**Zoning Board of Appeals
October 23, 2013 Regular Meeting**

STAFF REPORT

Subject: ZBA13-022, 2020 Camelot

Summary: Gary Turner is requesting one variance from Chapter 55(Zoning) Section 5:57 (Averaging an Existing front setback line), of 7 feet for expansion of an existing residential structure into the front setback; 30 feet is required (Averaged Front Setback).

A SITE PLAN
 1" = 20' - 0"

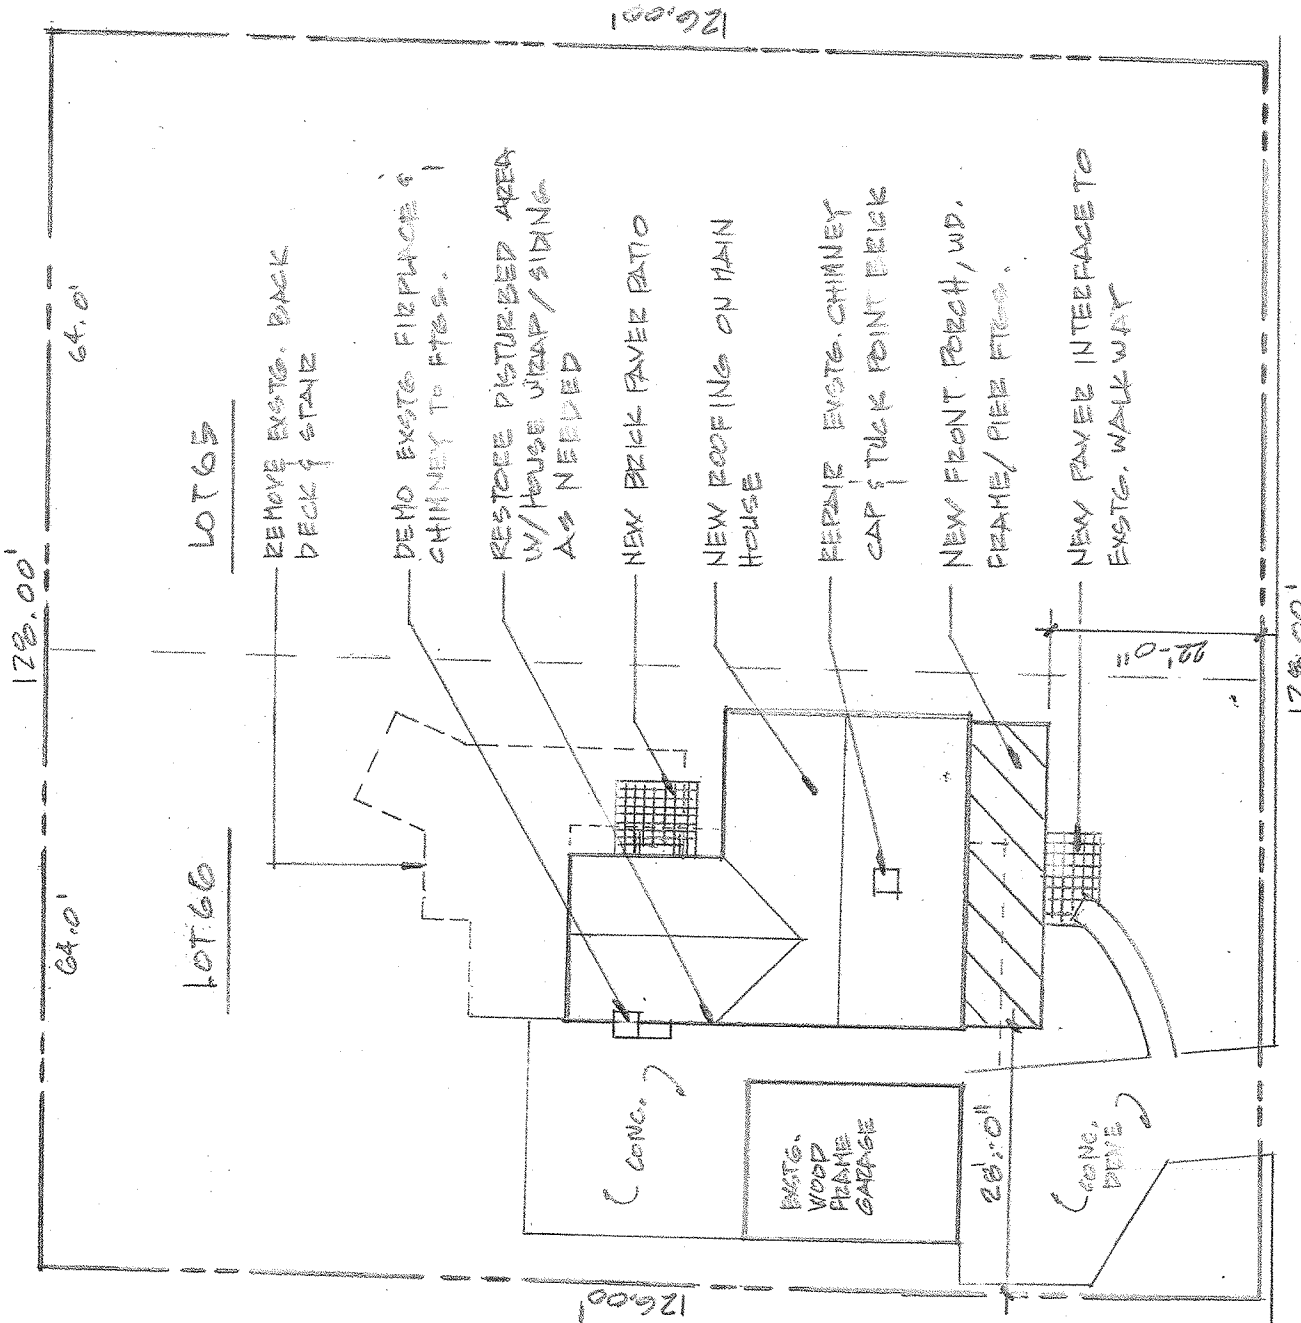
The petitioner is proposing to remove the existing uncovered deck and construct a new covered, but not enclosed, front porch measuring 7 feet by 29 square feet or 203 square feet. The front setback to the porch will be 23 feet. The porch roof addition will match the rooflines of the structure and will be supported by columns.

Although the required front setback is 25 feet for the R1C zoning district, the averaged front setback at this location results in a required front setback of 30 feet. The total encroachment of the house after the porch addition will be 7 feet.
